RE: Silver Star Auto Haus

5111 Wilshire Ave. NE

Engineer's Stamp Date: 5/1/2018 Hydrology File: C17D014A1

Based on the information provided in the submittal received on 5/1/2018 the above-referenced Revised Conceptual Grading and Drainage Plan is approved for Site Plan for Building Permit. The following comments must be addressed prior to approval for building permit and SO-19 permit.

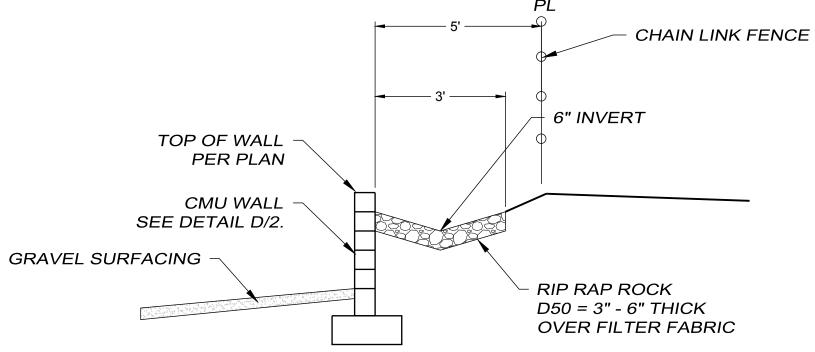
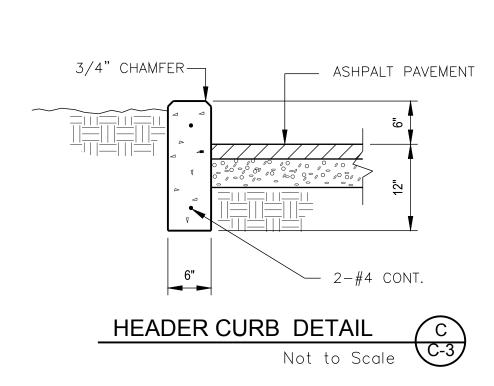
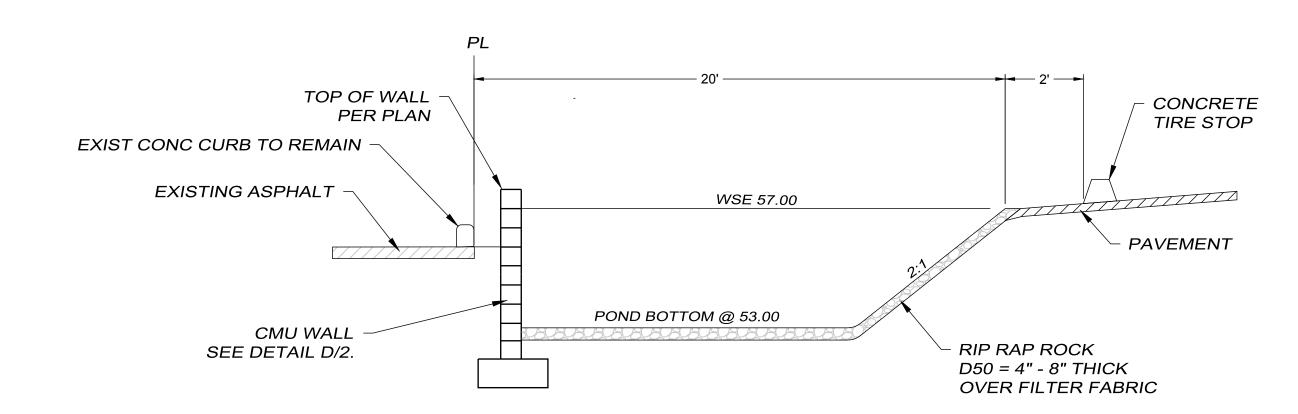
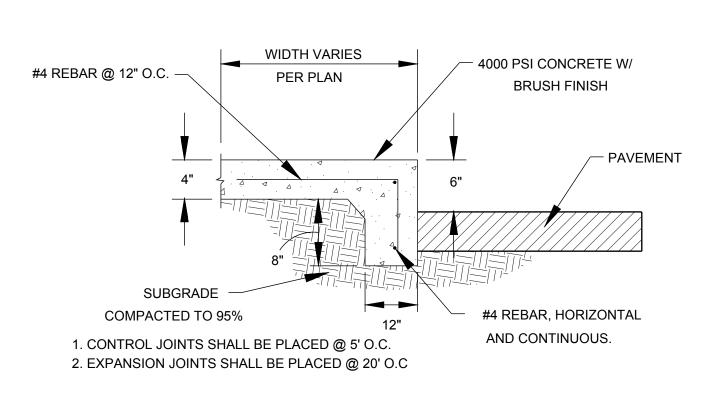
- 3. Please consider moving more of the retaining walls away from the property lines to keep the footer out of the soil friction plain, especially in front of the building where the parking spaces can easily be slid west a little. Add a note on the plan view stating that "no encroachment is allowed into the neighbor's property without written permission and any damages to the neighbor's property must be repaired". Alternatively consider adding a requirement for piling and/or shoring of the taller cuts.
- 4. Pump specifications and performance curve are required. They should be added to the G&D Plan and the information should be included in the Drainage Covenant.
